2ND ST & MARKET

DATE: 01-09-19

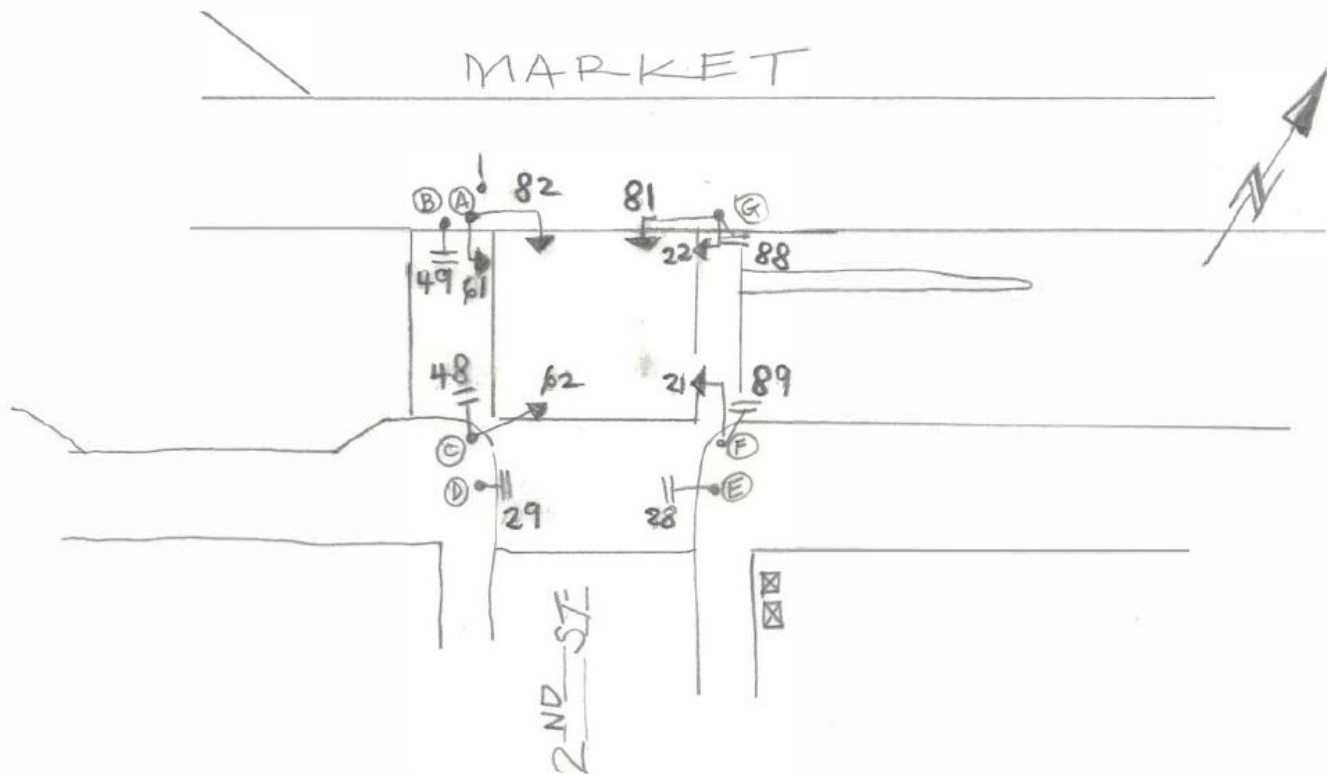
• Changed 81 & 82 to be 8" FY signal heads & updated numbering to match timing card. Ian Tront SRC 2018-473
